MIDVALE PLANNING AND ZONING COMMISSION
SPECIAL MEETING AGENDA
JULY 22, 2020
7:00 pm

APPLICATION:	7100 S - PEAK VIEW FLATS
LOCATION:	127-149 E 7100 S
APPLICANT:	Ridgeway Construction - Chris Knapp
FILE #:	SUB - 22-30-106-019; 22-30-106-020; 22-30-106-021; 22-30-127-006
REQUEST:	PRELIMINARY SUBDIVISION
MEETING DATE:	July 22, 2020 (Continued from July 8, 2020)
ZONING DESIGNATION:	Single Family Residential and Duplex Overlay (SF-1/DO)
AUTHOR:	Jana Ward, Planner I
APPLICABLE ORDINANCE(S):	Midvale Municipal Code Title 16 & Chapter 17-7-1
AGENDA #:	1

APPLICATION:	MEADOWS ON 7TH MASTER PLANNED DEVELOPMENT / PRELIMINARY SUBDIVISION
LOCATION:	6790 South 700 East
APPLICANT:	Brad Reynolds Construction
FILE #:	MPD/SUB – 22-19-477-016 and -005
REQUEST:	Conditional Use Permit / Small Scale Master Plan / Preliminary Site Plan / Preliminary Subdivision Plat recommendation for a 17-unit Master Planned Development
MEETING DATE:	July 22, 2020
ZONING DESIGNATION:	Single Family Residential Zone with Duplex Overlay (SF-1/DO)
AUTHOR:	Jason Binks, Senior Planner
APPLICABLE ORDINANCE(S):	Midvale City Municipal Code Title 16; Chapter 17-7-1.
AGENDA #:	2

APPLICATION:	FORT UNION PRELIMINARY COMMERCIAL SUBDI

SITE PLAN

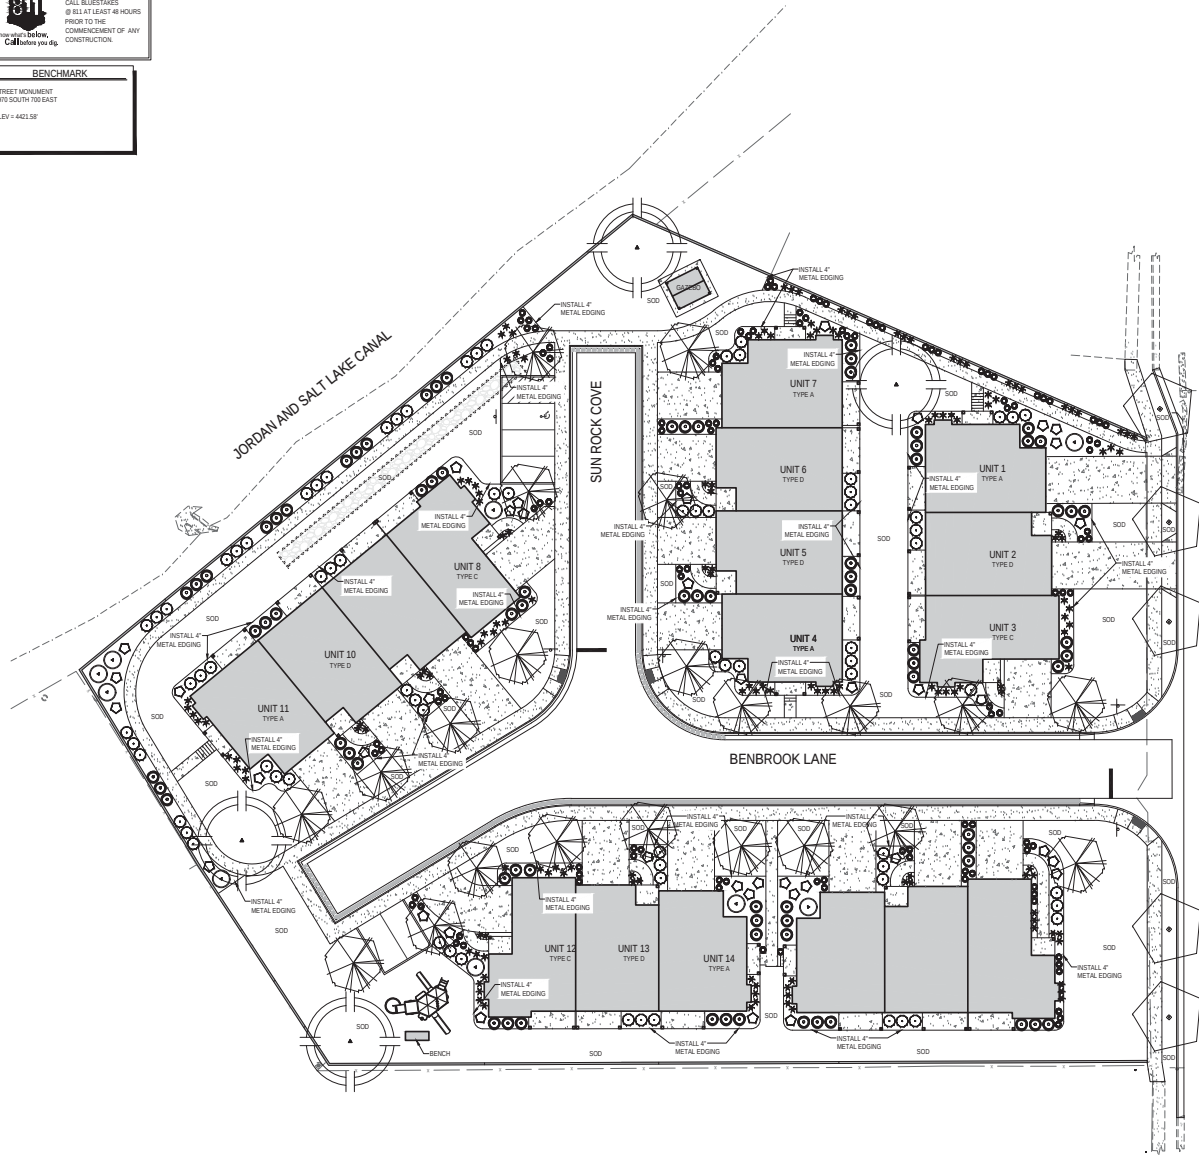
The Fire Marshall approved the plans on 06/26/2020 with the note that no street parking is allowed with road widths of 20 feet. The applicant shall post no parking signs or use red painted curbing. did not comment on the sufficiency of emergency vehicle access.

The Site plan provides a total of 40 parking spaces. There are 2 spaces per unit and 6 guest spaces. For a master planned development, parking standards are determined by the Planning Commission based on the proposed uses and the potential for shared parking. The Planning Commission typically allows parking at the ratio of 2.25 spaces per unit. The proposed subdivision meets these standards.

The submitted documents do not provide any details about the proposed precast concrete fences. There is a note that, because of the slope toward the canal, fencing will be 8 feet high viewed from the canal side and 6 feet high from the proposed subdivision. The difference comes from backfill against the fence on the subdivision side. There is a marked transition point whereby the wall will drop to the required 4 feet in the front yard setback along 700 East. Staff recommends a requirement that show fence details as part of the Final Site Plan application.

Private roads require street lights, and 4 street lights are indicated on the submitted utility plan. However, no information is provided regarding building lights or the overall, outdoor lighting plan, and whether the lights are adequately screened to mitigate impact on surrounding uses. Staff recommends a requirement for a Lighting Plan in the Final Site Plan application.

1. The applicant shall prepare a final site plan application to be reviewed and approved by the City Engineer, Fire Marshal, and Planning Staff.
2. All requirements of the Building Official, Fire Marshal, City Engineer, and Planning Staff shall be satisfied.
3. The final site plan application shall include the following:
 - a. Fence details including materials and façade of both sides.
 - b. A lighting plan with descriptions of all illuminating devices with manufacturer catalog cuts and drawings. A photometric analysis that shows lumens along the perimeter of the property.

SHEET NUMBER:
A201A

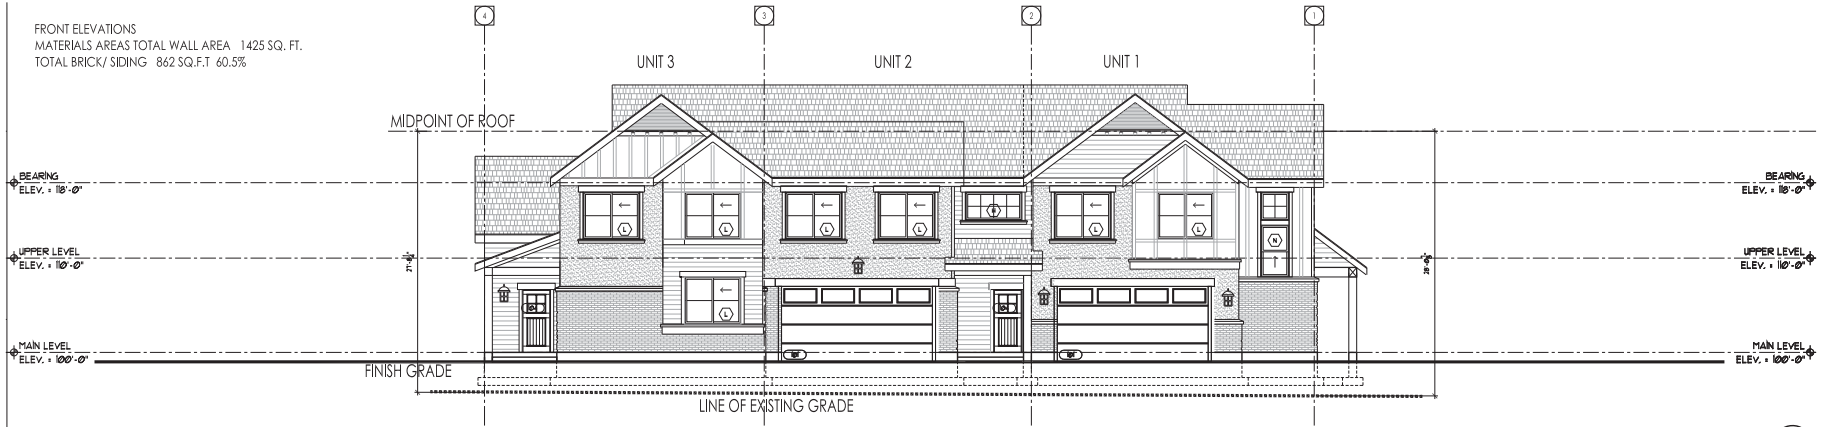
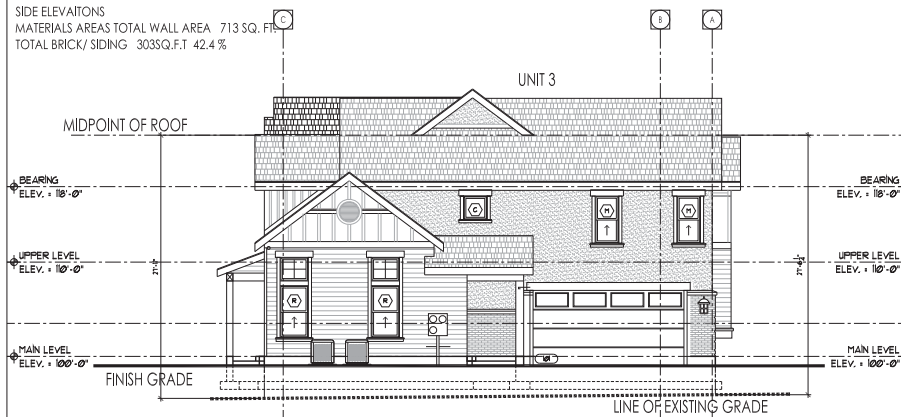
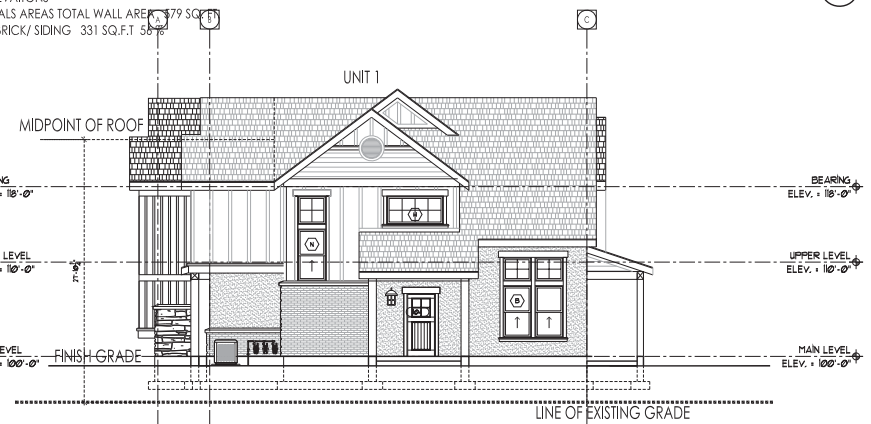
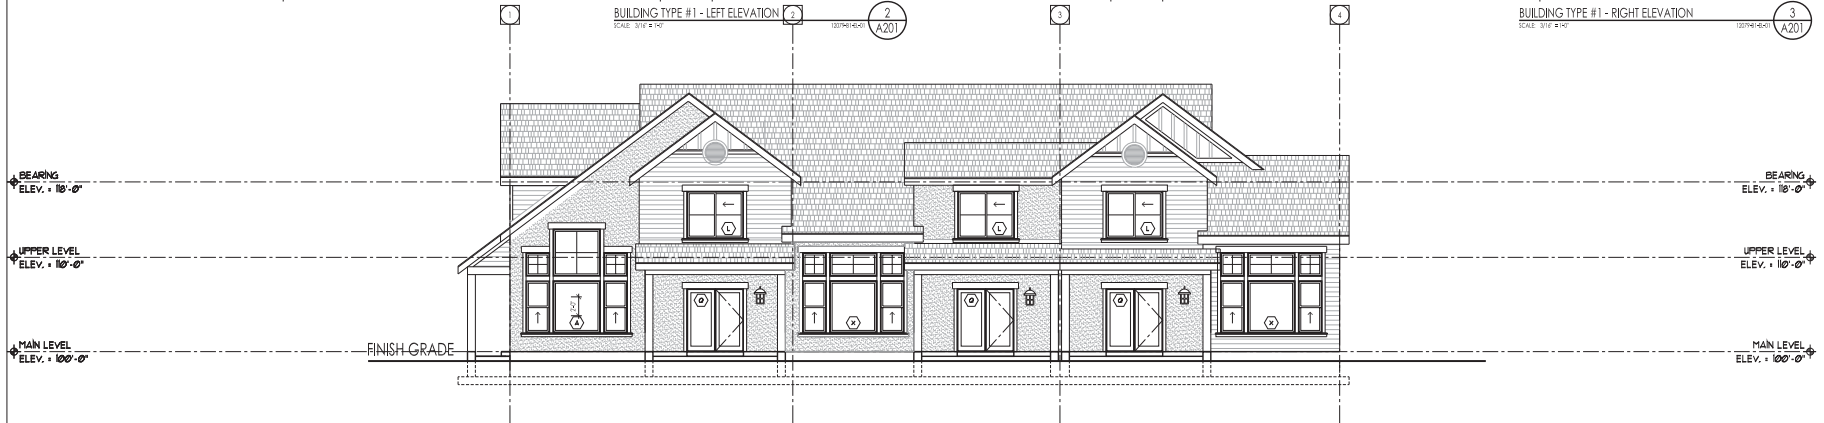
The elevations for each of the 5 structures show front facades with 60.5% brick/siding material, which meets the 60% front façade requirement in Section 17-7-1 (10)(C). Side elevations that face streets must also meet front façade requirements. There are four units (units 3, 4, 8 and 17) that have side facades that face streets. The submitted elevations for these four units only have 42.4% brick/siding material. All other side elevations meet the façade percentage requirement. Staff recommends a requirement that elevations for units 3, 4, 8, and 17 meet brick/siding façade percentages in the Final Site Plan application.

- c. Elevations that meet façade requirements for units 3, 4, 8, and 17.
- d. Install, or guarantee installation through a bond, that 2'-inch caliper deciduous trees will be installed according to the approved landscape plan.
- e. Those items required by the Salt Lake Public Utilities regarding the adjacent canal.
- f. Any additional documentation required by staff to adequately review the final site plan.
